## REMARKS

### 2. Drawings

FIG. 6

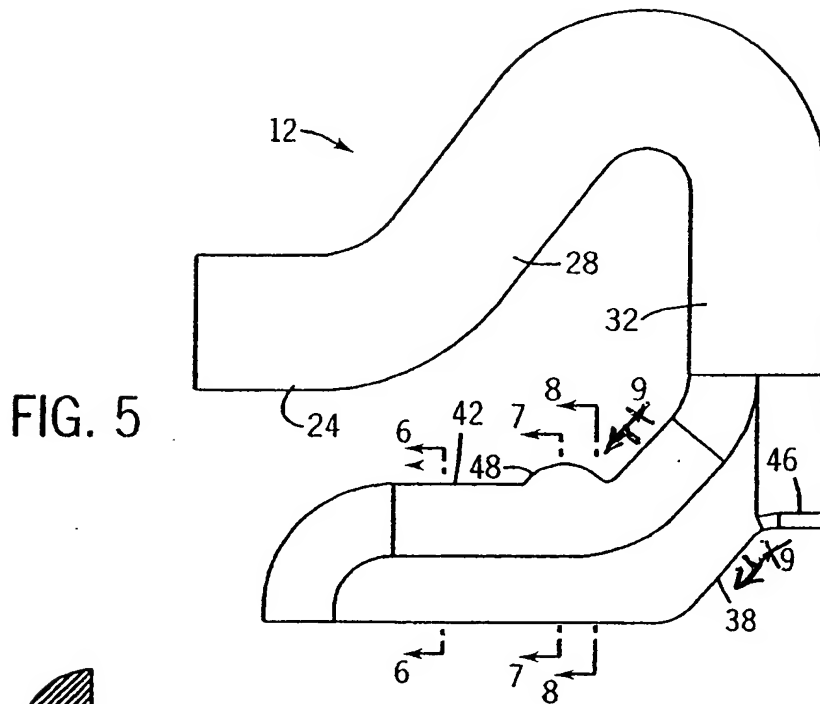
Proposed corrected FIG. 5 is also being submitted herewith to correct reference line 9-9 to match the orientation of the section shown in FIG. 9.

The enclosed marked-up drawings entitled "Annotated Marked Up Drawings" include proposed amendments to FIGS. 5 and 12 to correct reference line 9-9 and to include section reference lines corresponding to new FIGS. 15A-16B, now included in the enclosed set of formal drawings. These new figures bring the drawings into conformance with the disclosure of the specification and claims. Substitute drawings sheets entitled "Replacement Sheet" contain formal versions of FIGS. 5, 12 and 15A-16B.

ANNOTATED MARKED UP DRAWINGS

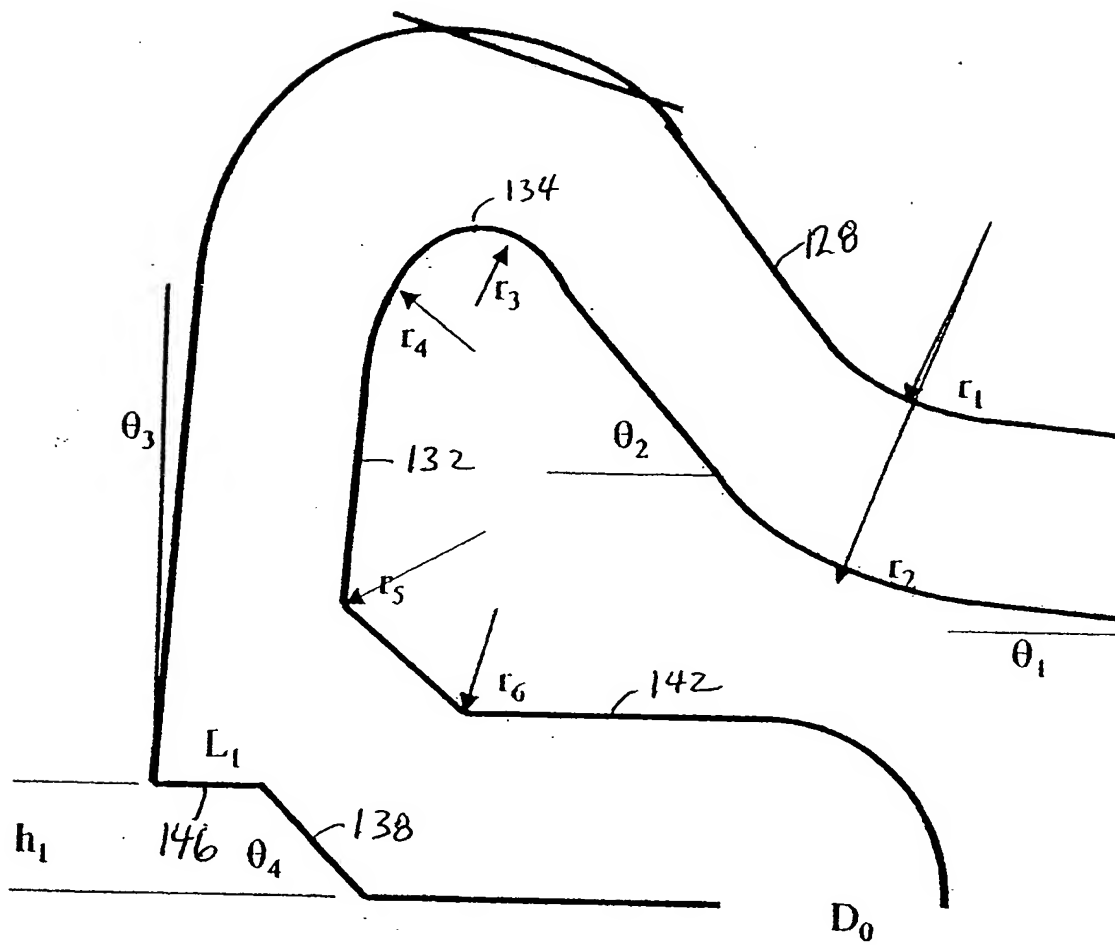
The drawings were objected to for not illustrating the subject matter of dependent claims 16 and 18. Proposed new FIGS. 15A-16B are being submitted herewith to illustrate alternate round and flat cross-sections for both the up leg and the out leg in the elected Fig. 11 embodiment. Support for these figures can be found in the written description at paragraphs 52 and 54, for example, as well as original claims 15-18 and the Table 1 at page 12. Thus, these new figures do not present new matter, but simply conform the drawings to the disclosure of the original specification.
